# LANDMARKS BOARD

RE: Landmarks Board Meeting

## MINUTES OF THE LANDMARKS BOARD

**DATE:** February 3, 2016

5FT. MAXIMUM HEIGHT   
 16SF MAXIMUM COPY

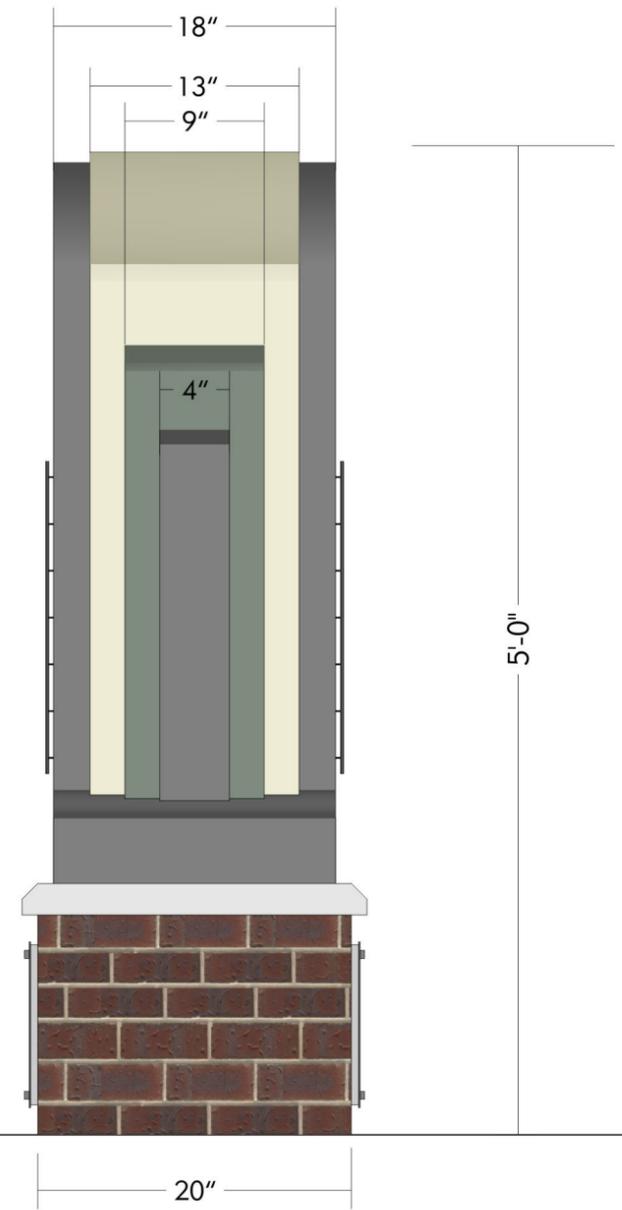
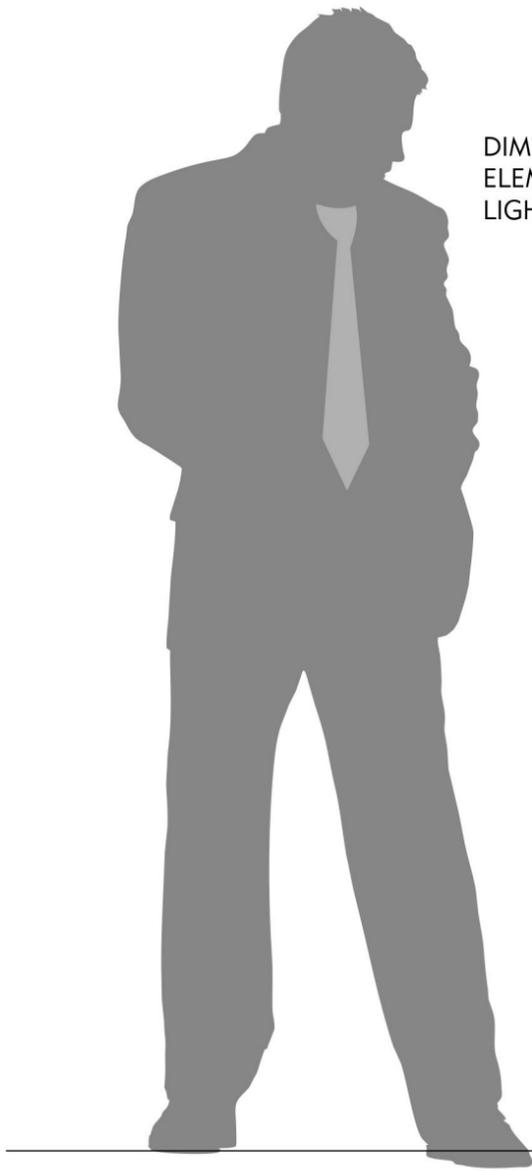
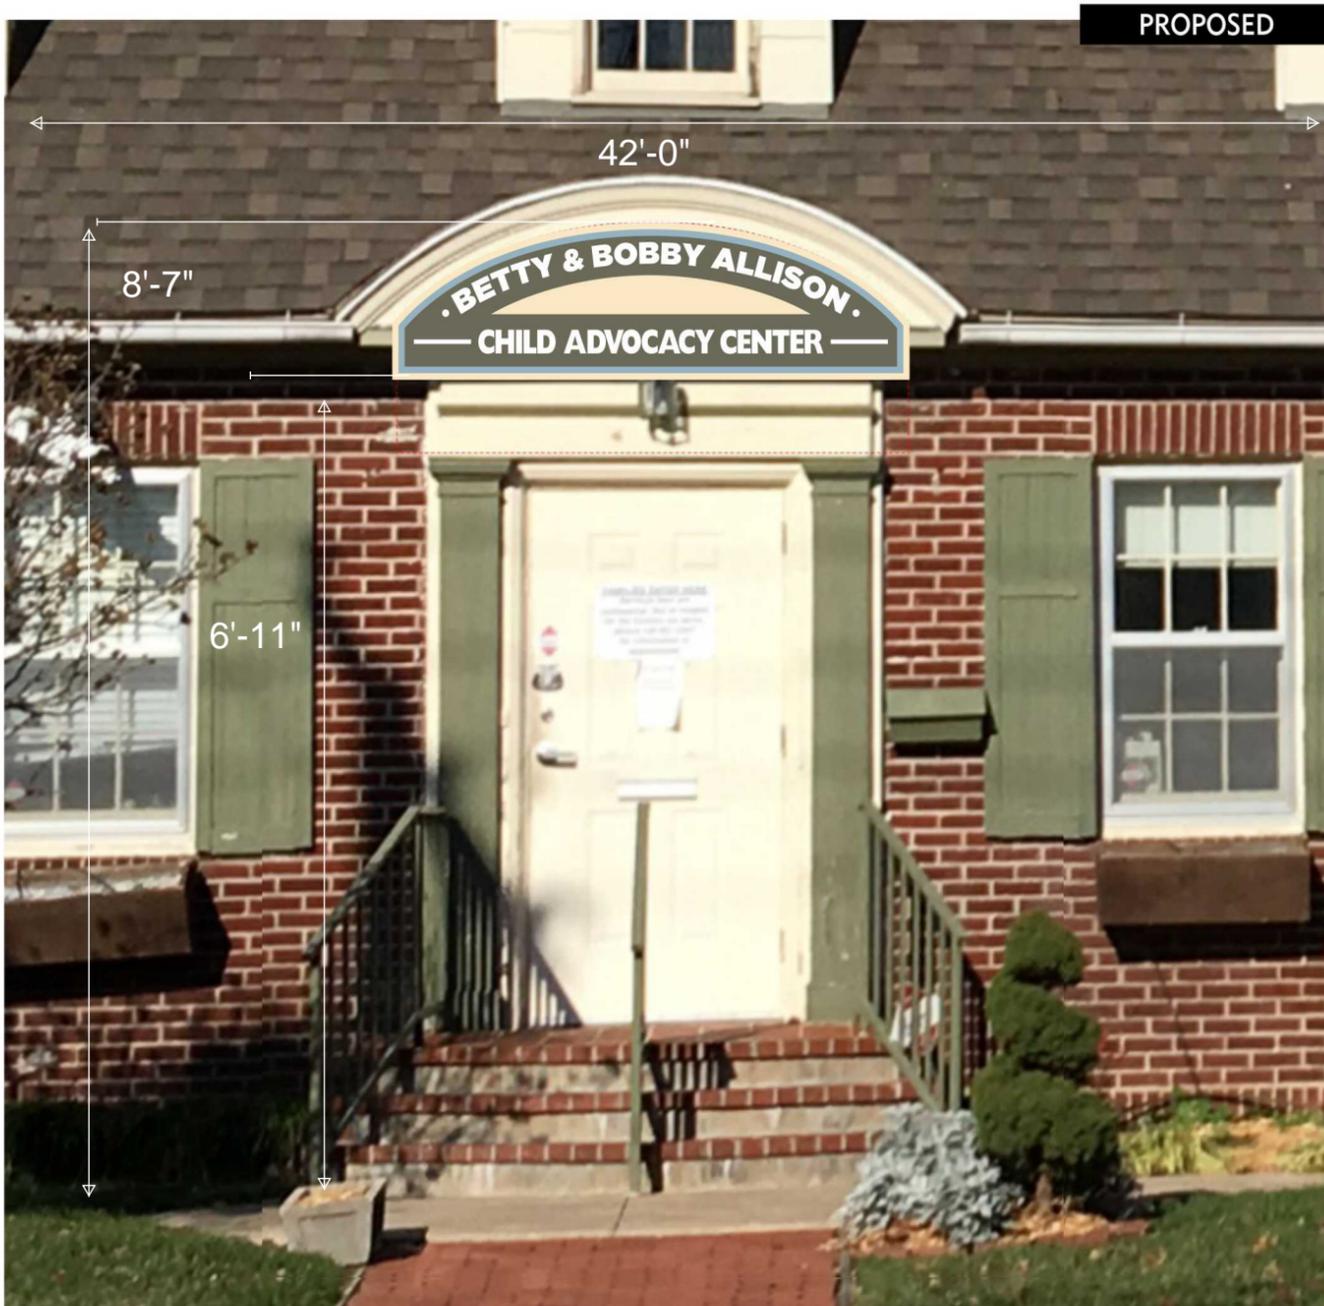
Mr. Harris states they amended the sign to meet the Western District criteria, the height being 5 foot. The square footage on the sign will be slightly over the 16 inches allowed and asks that

Mr. Eslick asked if the sign sides could be smaller than 24 inches.

Mr. Eslick stated that it needs to stay within the 16 square foot due to precedence within the Walnut Street area.

Mr. Eslick stated that he believes the monument sign should a different type of sign because all of the signs (Walnut Street) are alike, but with a narrower profile.

Mr. Harris that they can shrink the sign.

South Elevation

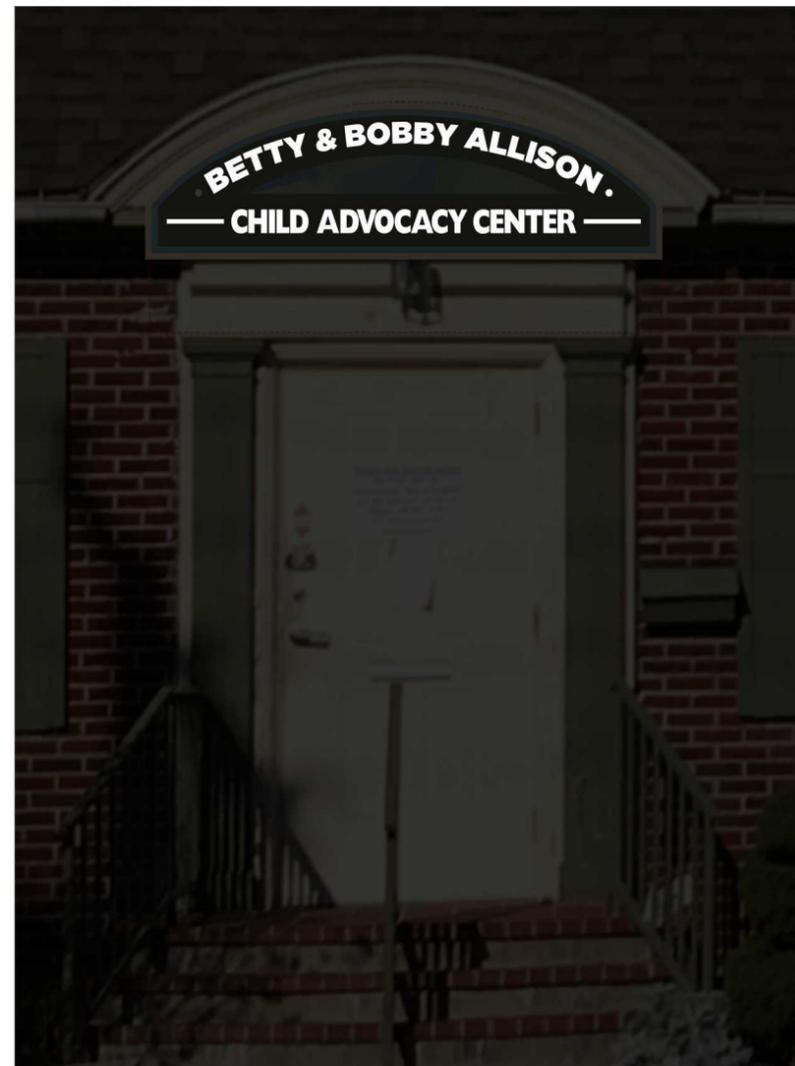
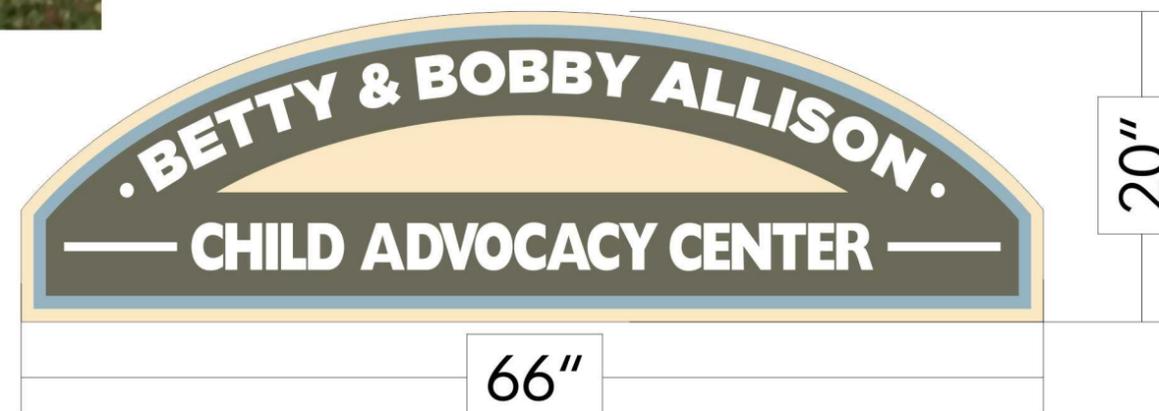
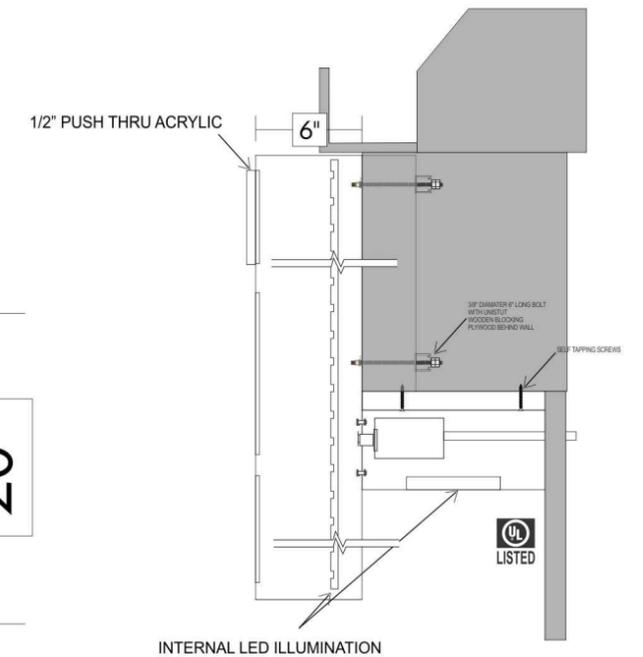
Mr. Eslick stated that the sign over the door is too big and is bigger than it should be and also looking at the other signs on Walnut Street will it not fit in with the rest of the signs. He stated that he likes the idea of the signs being kid friendly.

Mr. Bishop stated that he really likes the design of the art and whimsical nature and thinks it adds an element of differentness and knows that the interior guidelines warn against a certain sameness developing in the signage. He stated the issue is with the scale of it and not necessarily the 16 square foot limitation but the profile is larger and thicker than it should be. He would like it to be shrunken down. He also stated that the sign over the door (south elevation) is redundant and doesn't understand the need for it. The back sign is fine.

Mr. Harris asked if the wall sign (south elevation) was reduced, would that elevate some of the concerns. Since the Child Advocacy Center now has two buildings, having a sign over the door is important to direct client traffic.

Mr. Bishop stated that the monument sign is really a matter of taste and scale, but the sign on the front (south elevation) really effects the architectural lines of the building and that is more the essence of what this board is about and maintaining the integrity in this neighborhood and that is why I object to it as well as changes the system of way people use signage on this street.

Ms. Crandall agrees that the sign over the door is redundant and takes away from the building. It is too big and takes away building and does not know why it is lit up at night and asked if this was a 24 hour building.

Mr. Eslick and Ms. Crandall asked about resizing and taking off some of the language on the wall sign (south elevation).

Mr. Bishop stated that some of the issues for approval will be the sign over the front door unless it maintains the architectural integrity. He states that they are no other structures on Walnut Street with an over-the-door sign and stated his concern.

Mr. Darren Pearce, 505 N. Glenstone Avenue, Pinnacle Sign Group states that the door sign can be reduced in size and some of the language to be able to show the decorative door archway and columns. He notes that having light-emitting diode (LED) lighting is a need for the monument as well as the front door sign due to the lack of current lighting at both addresses.

Mr. Harris states that they will resubmit the design.
